ADDENDUM

RFB NO. 316017 - ADDENDUM NO. 1

ROOF REHABILITATION

FOR: CITY-COUNTY BUILDING 210 MARTIN LUTHER KING, JR. BLVD. MADISON, WISCONSIN 2016 ROOF REHABILITATION	DRAWN BY: SRI	CHECKED BY: T. CULLITON	DATE: 06-22-16	FROM:  SRI Consultants, Inc. 3207 Laura Lane Middleton, WI 53562 608-831-5333	PROJECT # 15557.00 SHEET: Figure 1
	REVISED BY:

1 PARAPET FLASHING DETAIL
1 SCALE: 3"=1'-0"

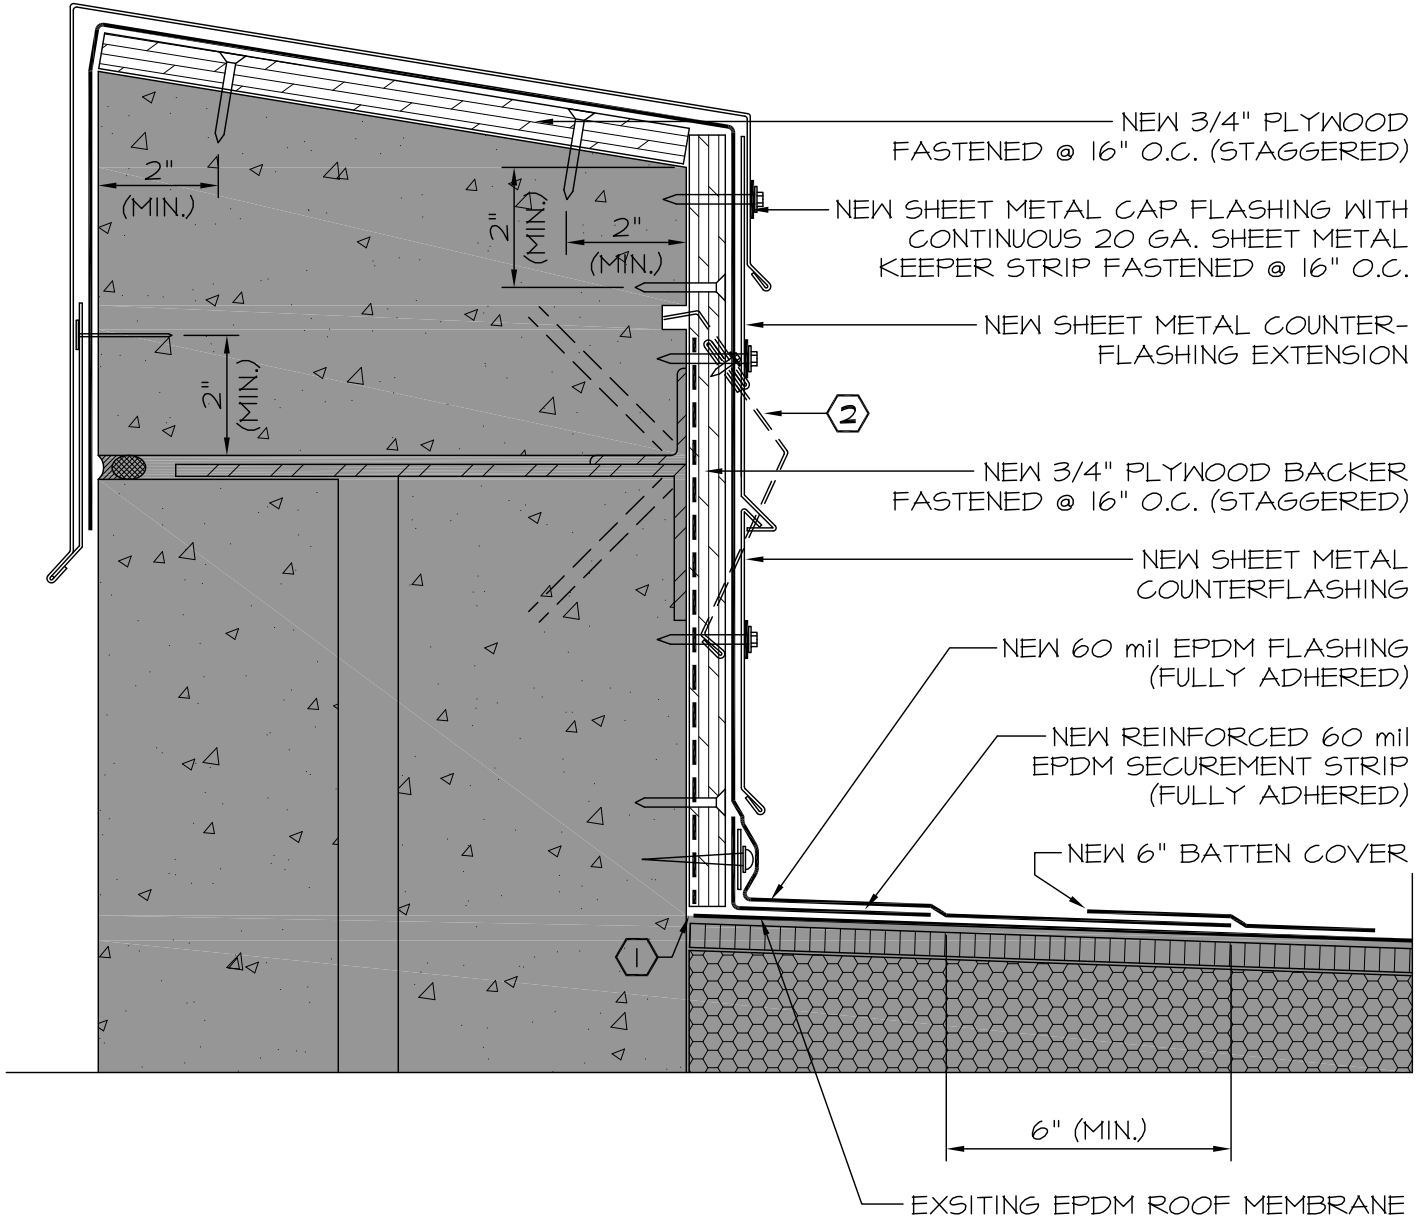
- 2. ADD:** Provide all Work with associated with providing sixty (60) lineal feet of parapet flashing (following Figure 1: Parapet Flashing Detail attached to this Addendum) to a length of parapet on the south east corner of the City-County Building (refer to Figure 2: CCB Roof Plan for location of Work). Existing Roof in area is to remain in place. Cost for this Work shall be included in the Base Bid. An informational per lineal foot cost shall be provided to the County for this Work following the Award of Contract. *Refer to Figure 1: Parapet Flashing Detail and Figure 2: CCB Roof Plan Sketch attached to this Addendum.*

- ① CUT EXISTING MEMBRANE AT ROOF/WALL TRANSITION
- ② REMOVE EXISTING SHEET METAL AND EPDM FLASHING AT WALL

NOTE: PARAPET CAP MAY VARY IN SIZE AND SHAPE
